GE VERNOVA

UR Family

Release Notes

Publication Number: GER-4882G

Changed "Error creating offline device" message on status bar when using URS file to "Add Device to Offline Window" option

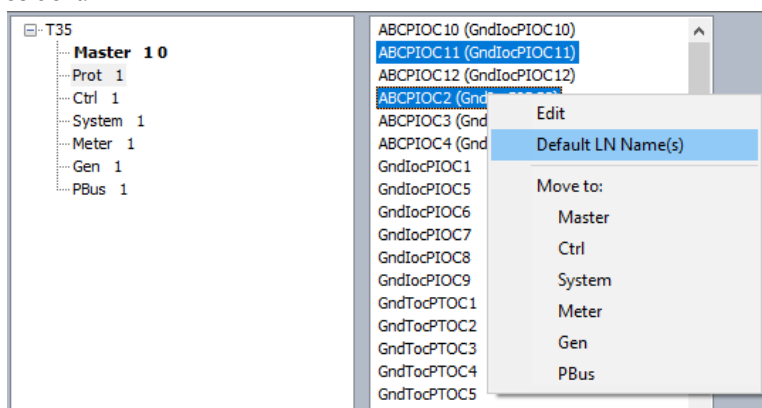
Description: When adding an offline device using a .urs file, the status bar shows "Error creating offline device." An untimely device integrity check during automatic SCL file generation fails, causing the error to be logged on the status bar. However, the device is added successfully to the Offline Window area.

The new release eliminates the automatic SCL file generation after a "Add Device to Offline Window" operation that uses a .urs file. A warning prompts the user to initiate SCL file generation manually using "Update SCL Files."
